**ALERT SERVICE BULLETIN**  
**Bell Helicopter** **TEXTRON**

NO. 407-07-80

DATE AUG 27, 2007

**SUBJECT:** TAILBOOM ASSEMBLY 407-030-801-107, AND 407-530-014-101/-103, NEW INSPECTION REQUIREMENTS.

Figure 1. Location of identification plate, tailbooms 407-530-014-101, 407-530-014-103 or 407-030-801-107

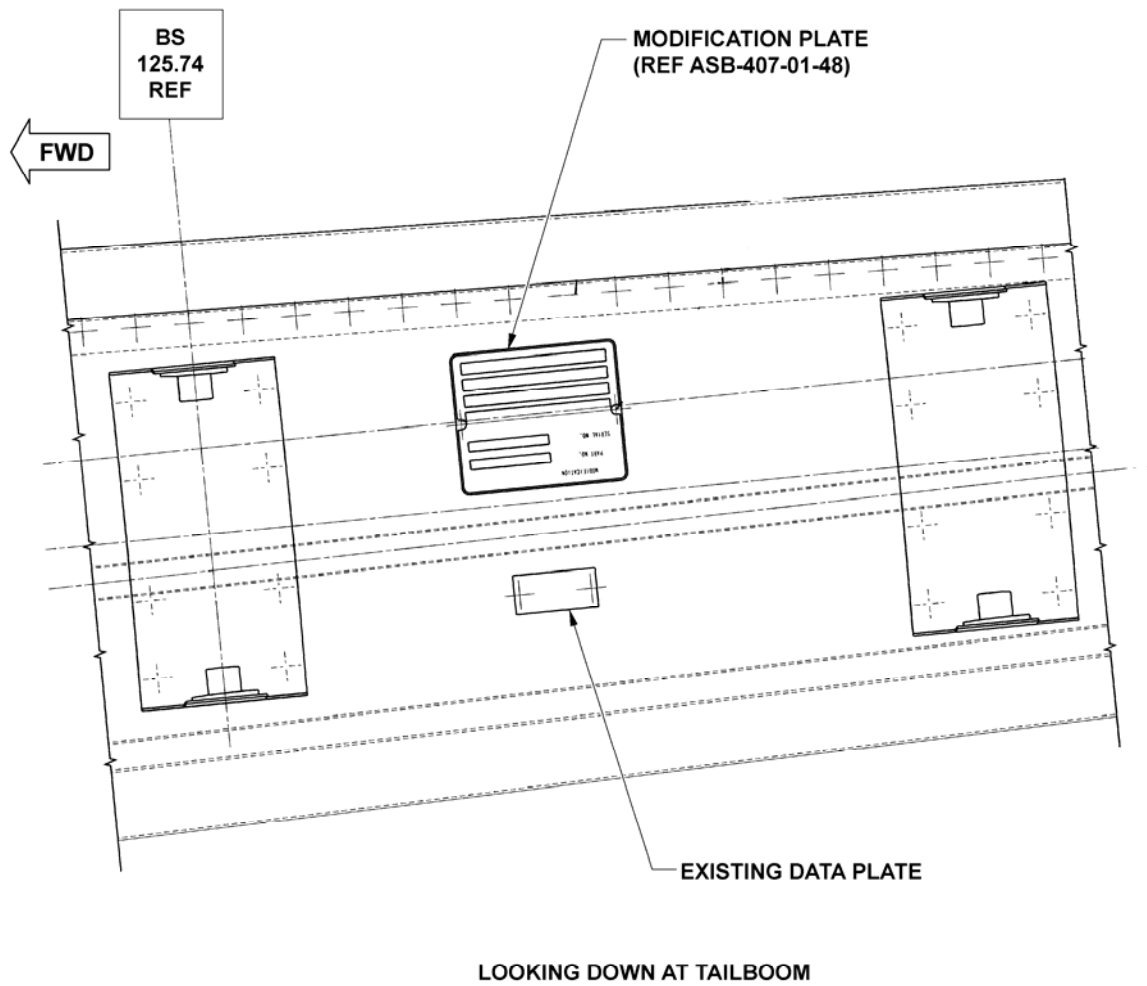
1. Upon receipt of this bulletin, verify the helicopter technical records to determine if you have a tailboom 407-030-801-107, or 407-530-014-101/103 installed. You can also physically confirm the tailboom part number by removing the aft driveshaft cover and looking at the identification plate located near Boom Station (BS) 129 as shown in Figure 1.

Figure 2. Daily check, tailbooms 407-530-014-101, 407-530-014-103 or 407-030-801-107

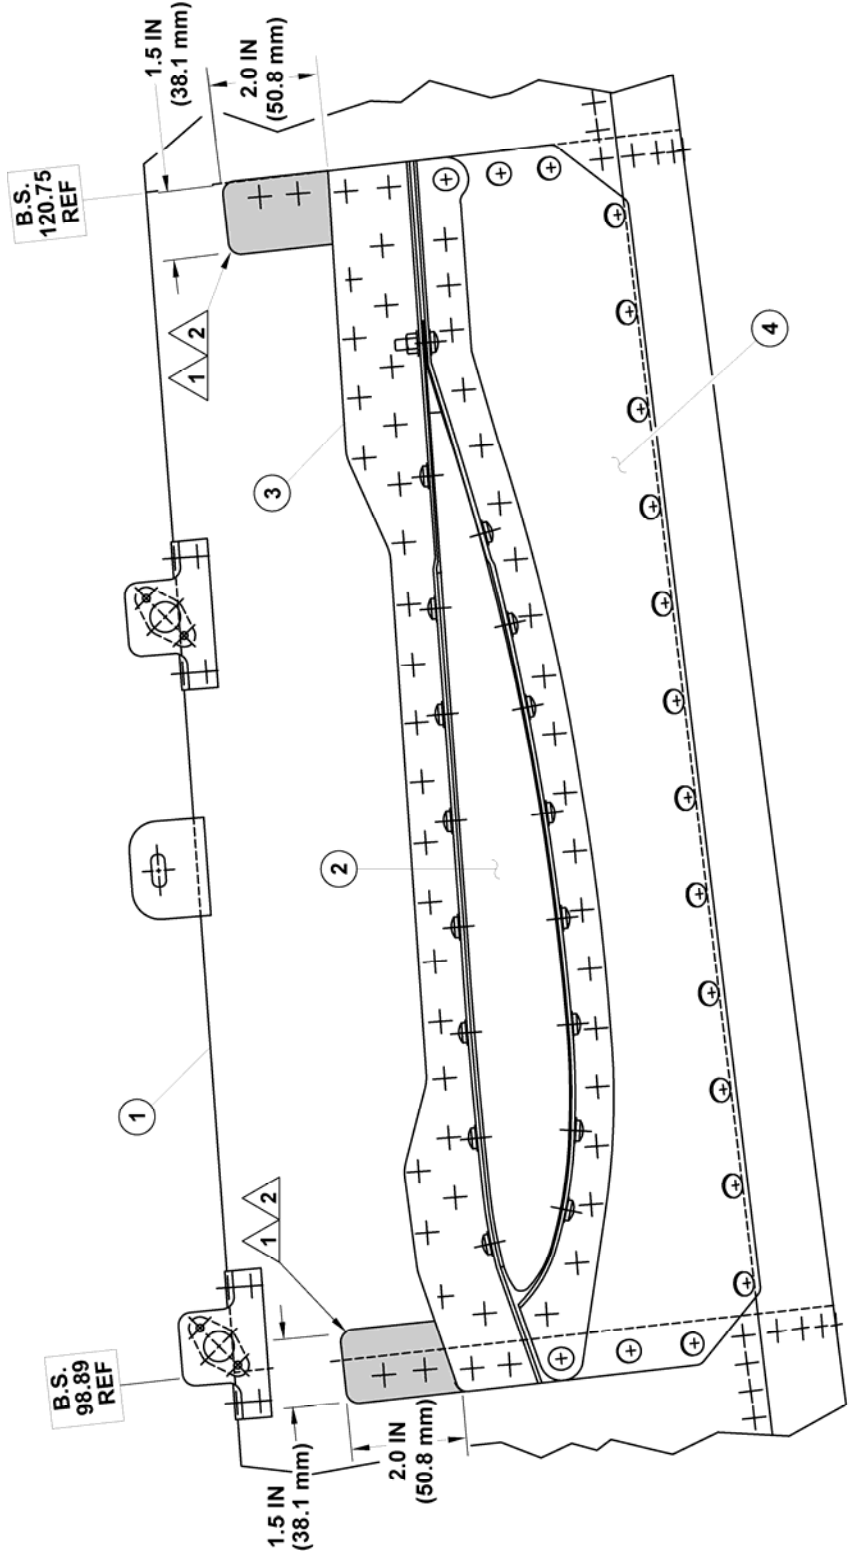
1. Remove the paint and primer from the left side only of your tailboom in the areas ( 1.5 inch X 2 inch( 38.1 mm X 50.8 mm)) shown under Figure 2 as follows;

- a) Use soap (C-318) prepared in accordance with manufacturer's recommendations to clean all exhaust residues and dirt from the tailboom surfaces shown in Figure 2.

- b) Refer to Figure 2 and use a felt marker to layout each area where the paint must be removed.
- c) Use Aluminum tape (C-439) to mask external area of each section identified in previous step. Make sure you put sufficient pressure over complete surfaces and edges of tape to get ultimate adhesion to the painted surfaces.

- a) Use a clean cloth moistened with aircraft soap (C-318) prepared in accordance with manufacturer's recommendations, as required, to remove any exhaust residues or dirt from both areas to look at, as shown in Figure 2.

- b) Make sure that the tailboom skin is clean and that adequate lighting exists. Visually look at the two areas where original paint and primer was removed and protected with clear paint coating. Look for a crack at a distance not exceeding more than 12 inches (30.48 cm) from eyesight.

- 1. Paint and primer to be removed from these areas (see PART II).
- 2. Examine these areas for cracks on left side of tailboom only.
- 3. Horizontal stabilizer not shown for clarity.
- 4. Daily check area
